Disposal No. P.773/35

NOTICE UNDER SCHEDULE VI CHAPTER XI, RULE 2 (I) OF
THE CITY OF KARACHI MUNICIPAL ACT 1933.Karachi 27 / 11 / 1933.

PROPOSED ADDITIONS IN OFFICE BUILDING ON PLOT NO 102, 103 SHEET NO M.M.7 MACHI MEANEE QUARTER

BUILDING SURVEYOR'S REPORT.

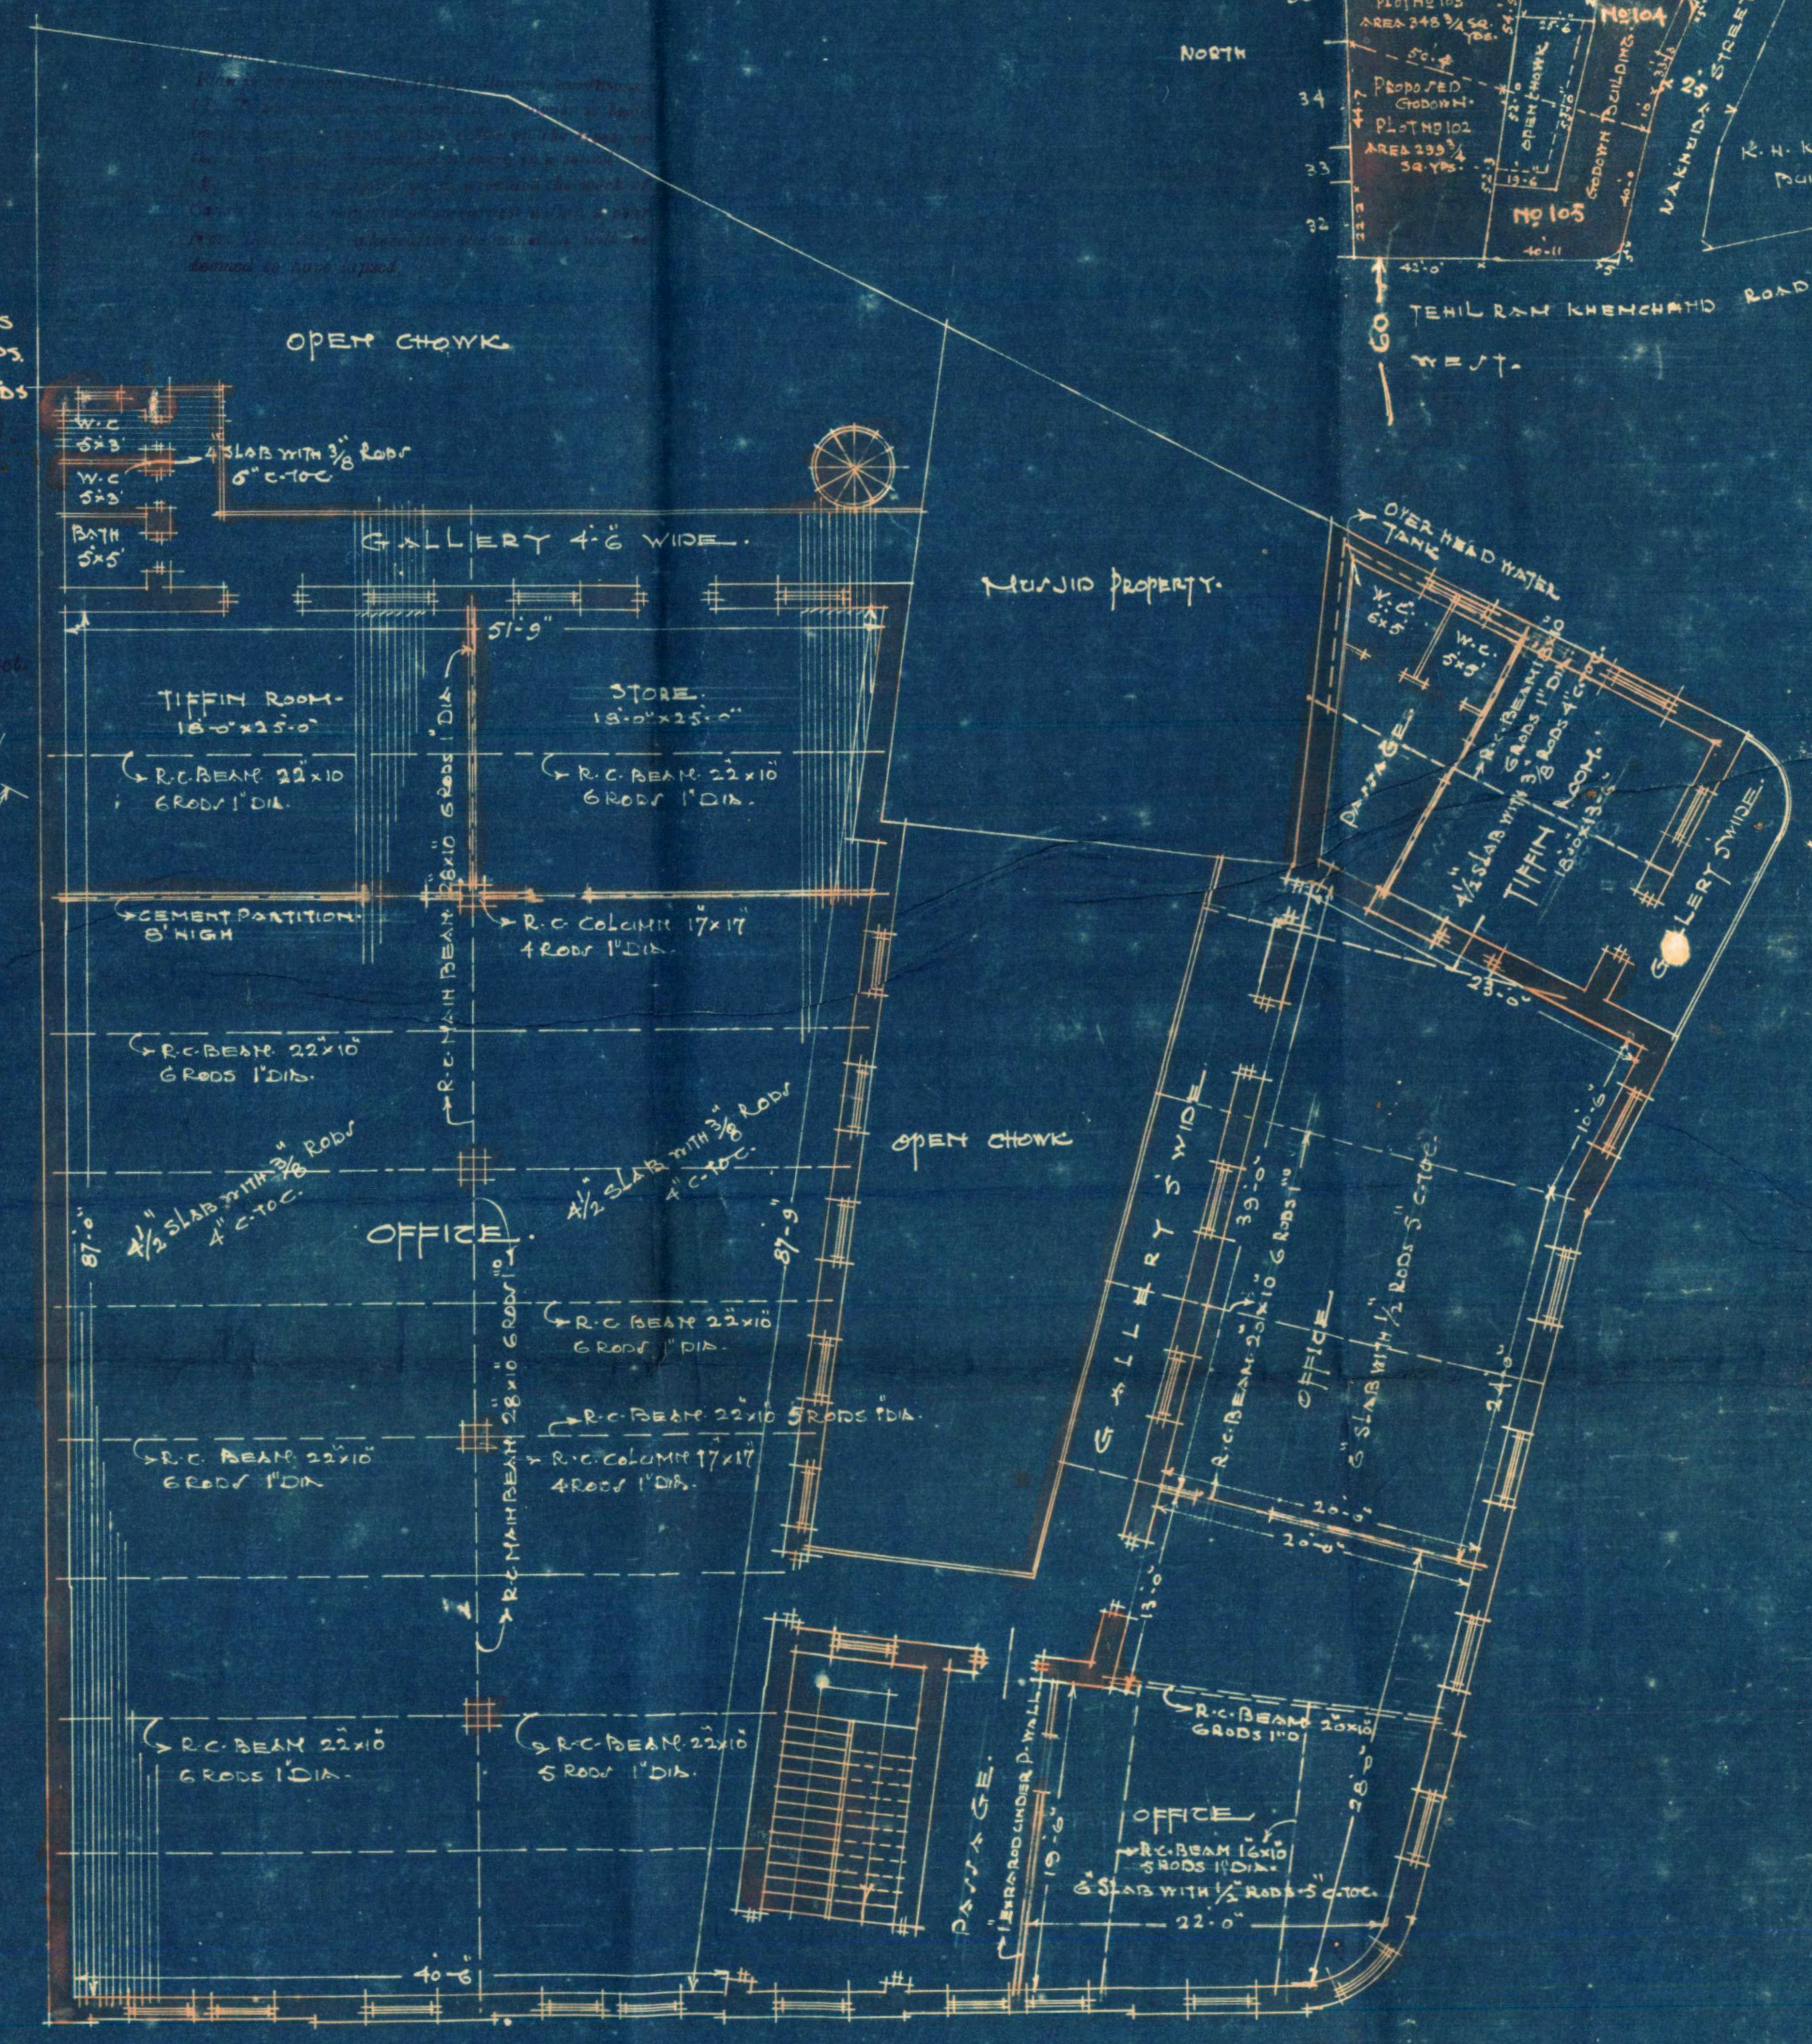
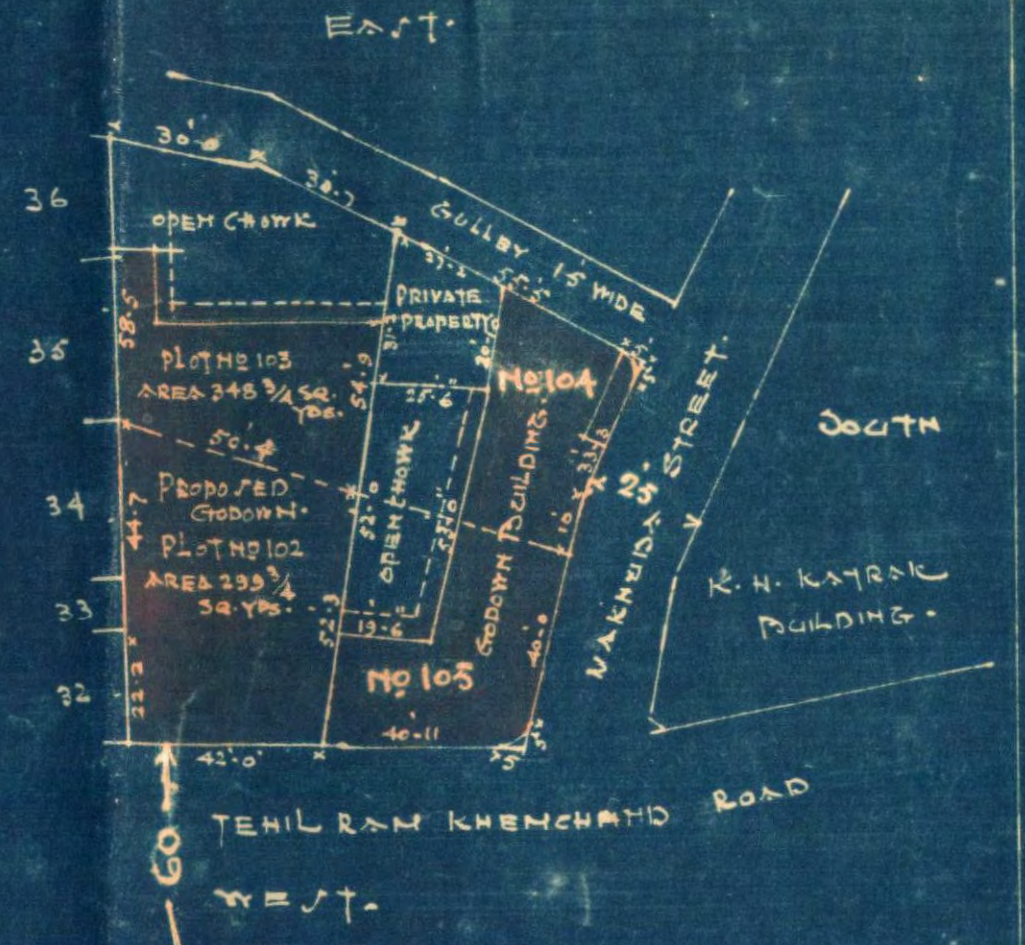
The thickness of walls provided for the proposed height are $18\frac{1}{2}$, $18\frac{1}{2}$ & 14 " the masonry being of cement blocks.

The 1st floor walls however however are 15 " thick instead of $18\frac{1}{2}$ " thick as required

This cannot be classed as "domestic" bldg. being clearly a part of the ware house class. Under the circumstances the thicknesses required would be 21 ", 18 " & 14 " for the 1st, 2nd & 3rd upper floors. You have probably, by an oversight taken this as "domestic" bldg.

over $30'$ the thickness is to be 18 " 16 " & 12 "

I therefore see no reason to

object specially where there are

pillars in the grill - The calculations

for loads comes to 6 Tons only

I see your point & very much appreciate it. In this case the L.F. is a Godown for which purpose the thickness is all right & 1st & 2nd are for office purposes for which too the thickness are all right & therefore the plan is approved with the proviso that the diversion to it use as a 1st floor Godown will not be made without obtaining written permission from the Land Manager and Architect
